Application for Works Approval Amendment

Works Approval Number W6640/2022/1

Premises Mt Ida Gold Project; Bottle Creek Premises
Mt Ida Road

Decision Revised Works Approval Granted

Figure 1 New proposed pipeline route

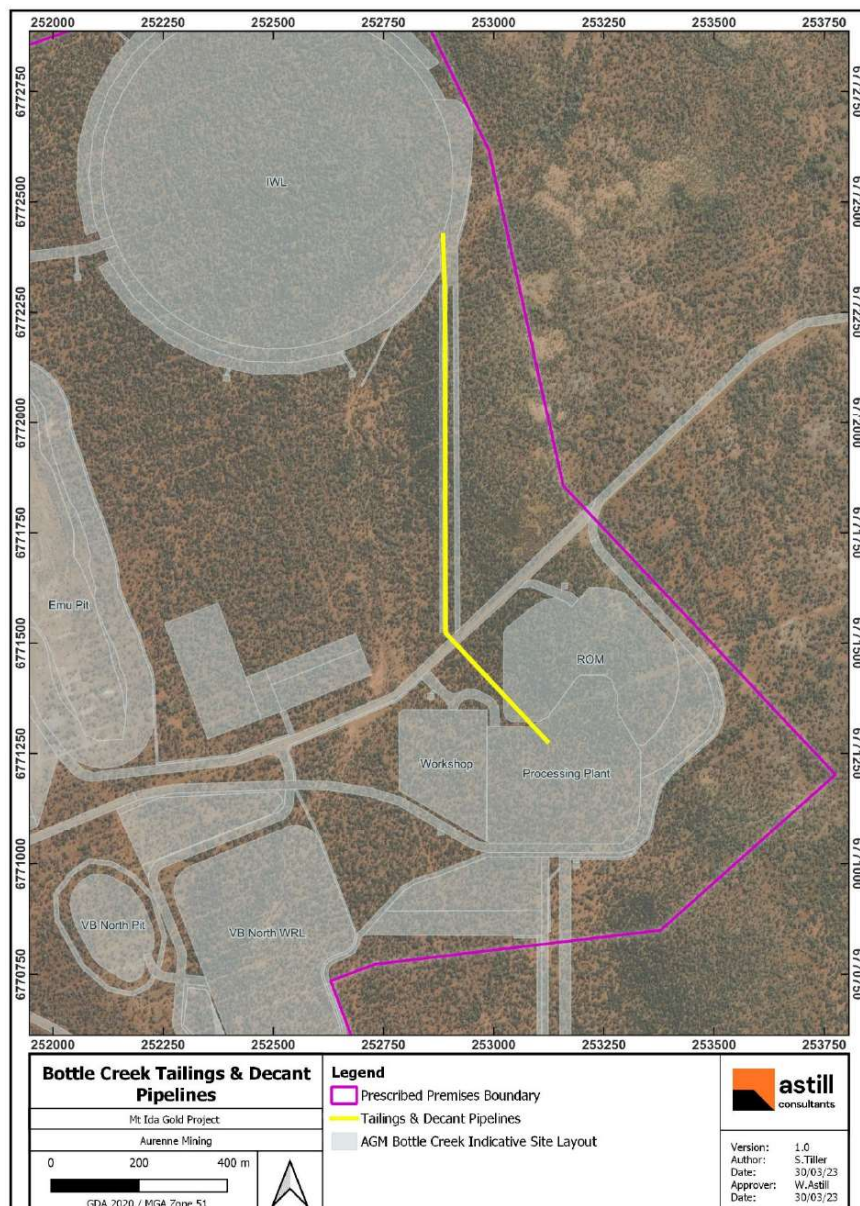
The new proposed pipeline () will be a straight line from the Bottle Creek processing plant to the eastern side of the IWL TSF. The new pipeline route is shorter and will result in less clearing and reduced pump pressure. The proposed pipeline has been approved by Clearing Permit 9383 and Mining Proposal Reg ID 101557.
